An Bord Pleanála Reference Number: 29S.JA0039

December 2016 Observation on further information on College Green Project -
Environmental Impact Statement and Planning Submission

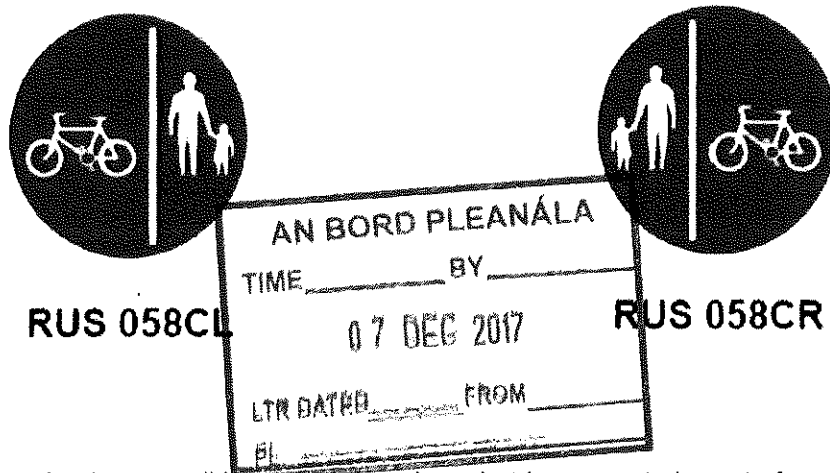
In only having a delineation paving strip on one side

It is unclear why the council is using these signs, but it seems to be out of some kind of misguided understanding of these signs give a higher degree of pedestrian priority than a cycle track or cycleway sign.

Where the cycle route going from east to west, to the left and to the right of the cycle path will be pedestrian area (the old footpath on one side and the plaza on the other) -- these signs ignore the fact that plaza is also a pedestrian area and might give both the impression and legal backing for cyclists to cycle on the main plaza area.

1. That there be a delineation paving strip on both sides of the cycle route throughout the plaza. REASON: for pedestrian and cyclist safety and for the independence and safe movement of pedestrian with visual impairments.
